APPLICATION NO.	FILING DATE	FIRST NAMED INVENTOR	ATTORNEY DOCKET NO.	CONFIRMATION NO.
10/554,172	10/24/2006	Jacobo Mugica Miguel	15053.0016USWO	7642
23552	7590	12/27/2007		
MERCHANT & GOULD PC P.O. BOX 2903 MINNEAPOLIS, MN 55402-0903			EXAMINER NGUYEN, TAM M	
			ART UNIT	PAPER NUMBER
			3764	
			MAIL DATE	DELIVERY MODE
			12/27/2007	PAPER

Office Action Summary	Application No. 10/554,172	Applicant(s) MUGICA MIGUEL ET AL. CT	
	Examiner Tam Nguyen	Art Unit 3764

DETAILED ACTION

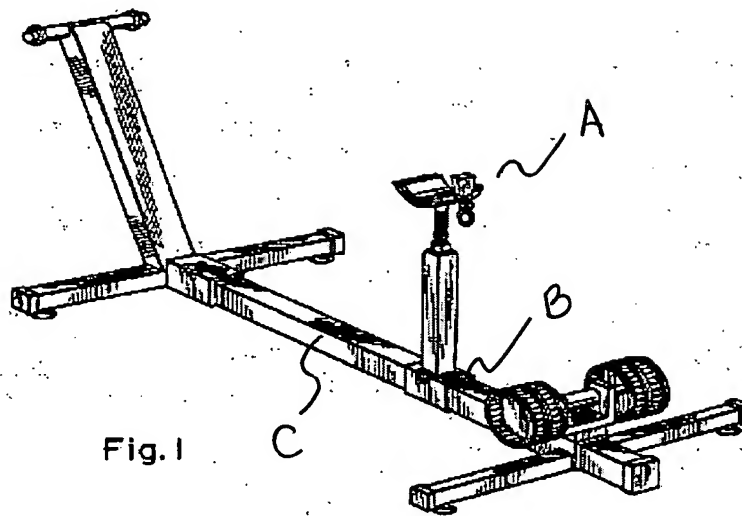
6. As to claims 1, 3 and 8, Defaux discloses a training bench having a framework (30) with two or more longitudinal bars, rotational rollers (31,31A) located between the bars, and a central support that includes a platform (35) assembled on the framework through transverse bars (35) on which it can move in a free or regulated manner, serves

as a holding base for a vertical column and provides a support means for the frame of the bicycle on it free end wherein the anchoring system acts as an absorption member to control the movement of a bicycle coupled to the platform and framework and the central support is connected to the pedal set casing of the bicycle (see Figs. 1 & 9).
